Application number, type . . . : 18 50043529 CP COMMERCIAL ADD & ALTER  
Property address . . . . . : 81 HOLLIES PINES RD

HARNETT COUNTY CENTRAL PERMITTING  
APPLICATION # 1850043529  
JOB NAME INDUSTRIAL CYCLES  
DATE PLANS RECEIVED 6.30.18  
SITE PLANS APPROVED \_\_\_\_\_  
APPROVED BY \_\_\_\_\_

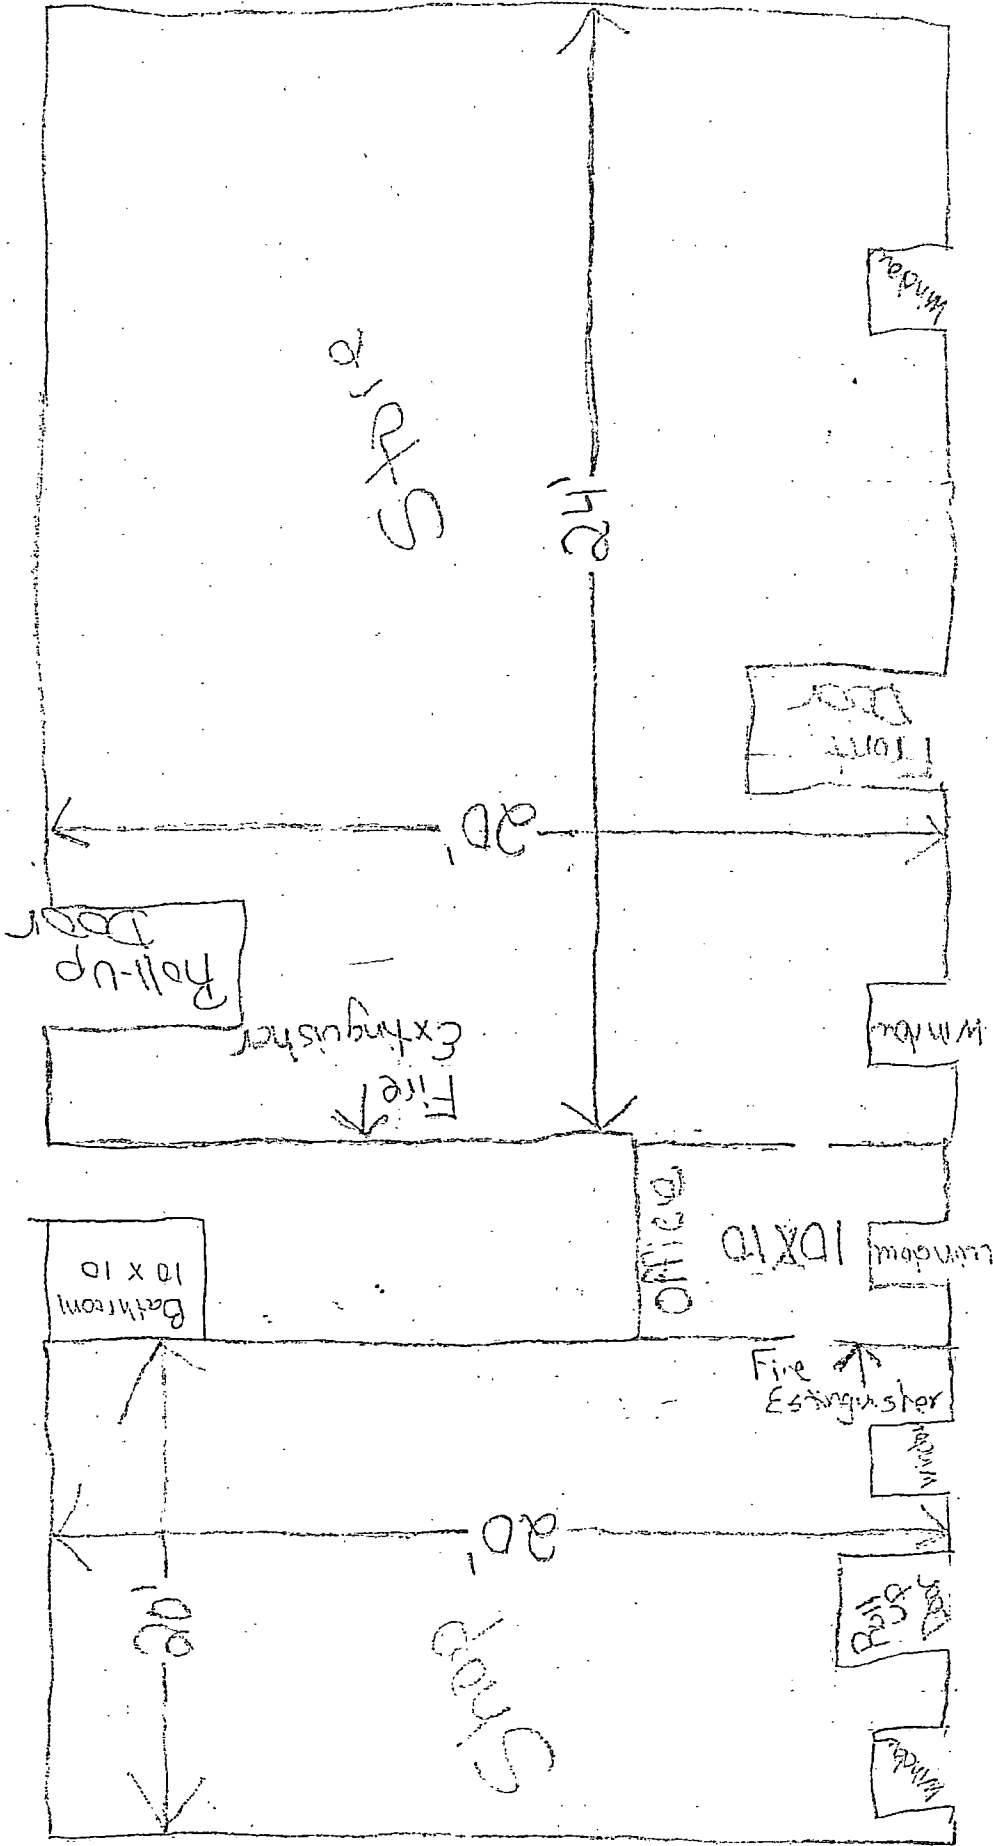
T/S: July 05, 2018 09:36 AM BSUTTON -----  
If the bathroom is to be located in the shop area, the plan  
must show a designated, accessible route, 48 inches wide,  
with no changes in elevation, from the store front door,  
through the office, and the shop. All doors shall be a  
minimum of 36 inches wide, with lever style hardware, and  
nothing may be stored in the designated travel area.  
Provide the engineered plans for building addition, with  
heating and cooling shown, as well as an electrical plan.

T/S: June 14, 2018 08:37 AM BSUTTON -----  
Must have an accessible, unisex restroom. Not shown on  
plan.
